**ADDENDUM No.1**  
**No. 2026-103**  
**Courthouse Parking Lot Upgrades**

**From questions brought up at the site visit on March 30, 2026.**

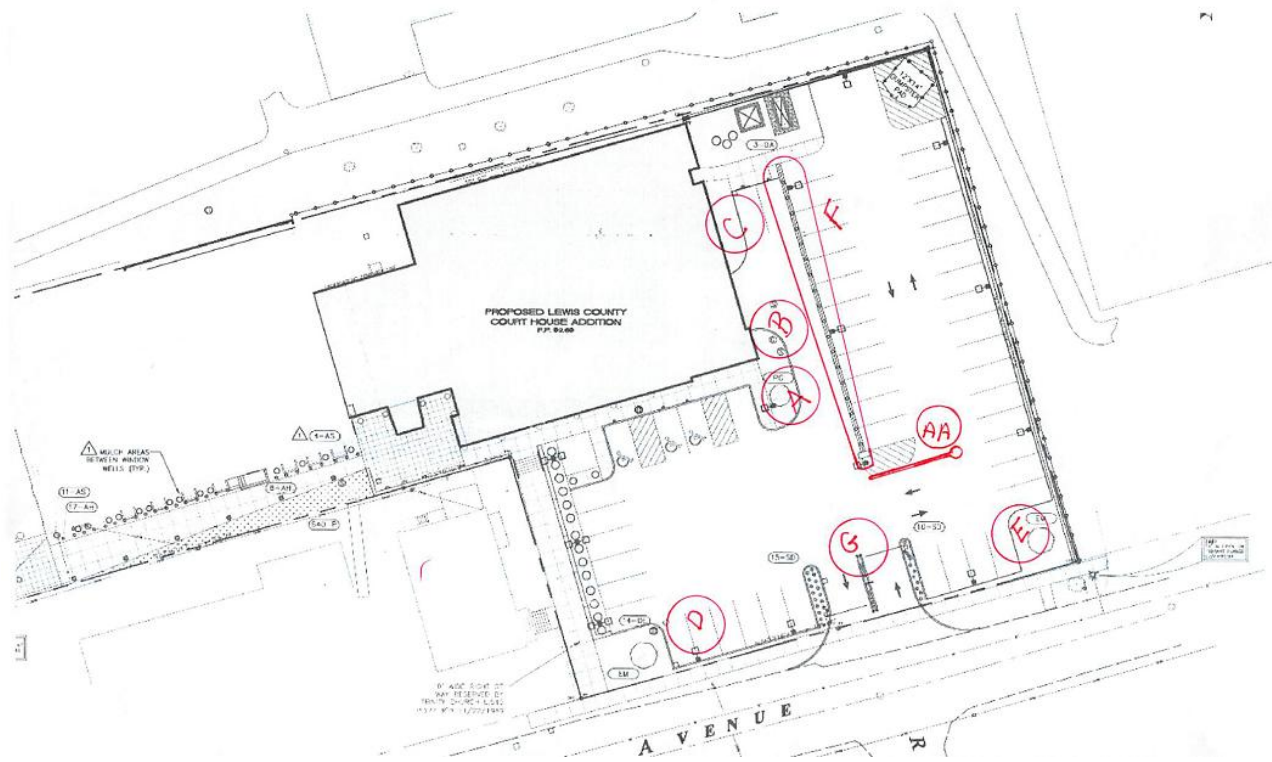
Please include as an alternate pricing for a 2x2x2 structure with approximately 30' of 8" corrugated pipe running to the existing structure at the end of retaining wall. The new structure is to be in the center of the drive line, noted AA on the attached map.
